World Forum for Harmonization of Vehicle Regulations

Working Party on General Safety Provisions

Report of the Working Party on General Safety Provisions on its 111th session (11-14 October 2016)

"Figure 1

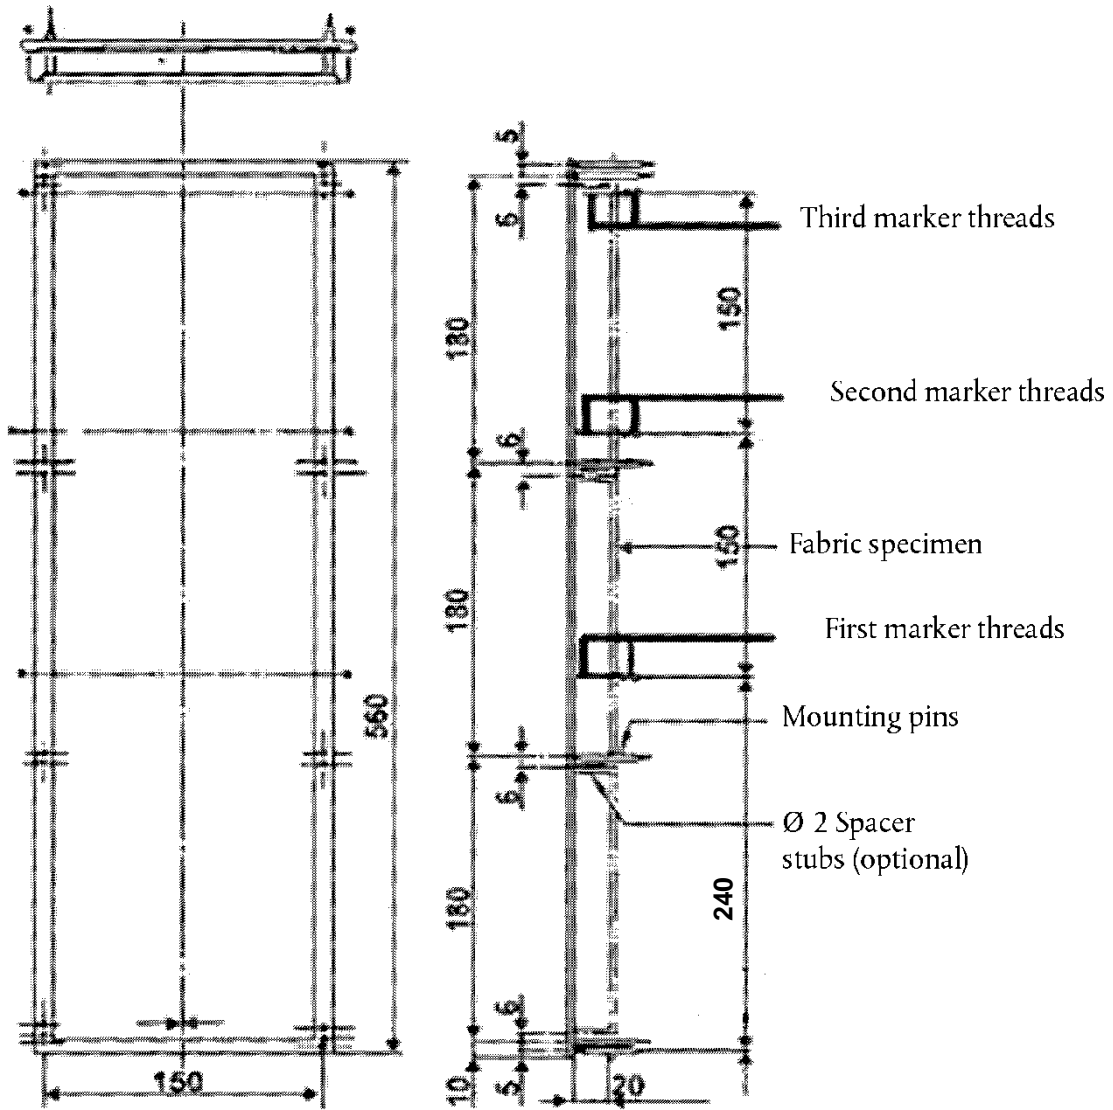
Figure 1, amend to read (removing "Burner" at the bottom and replacing "220" by "240"):
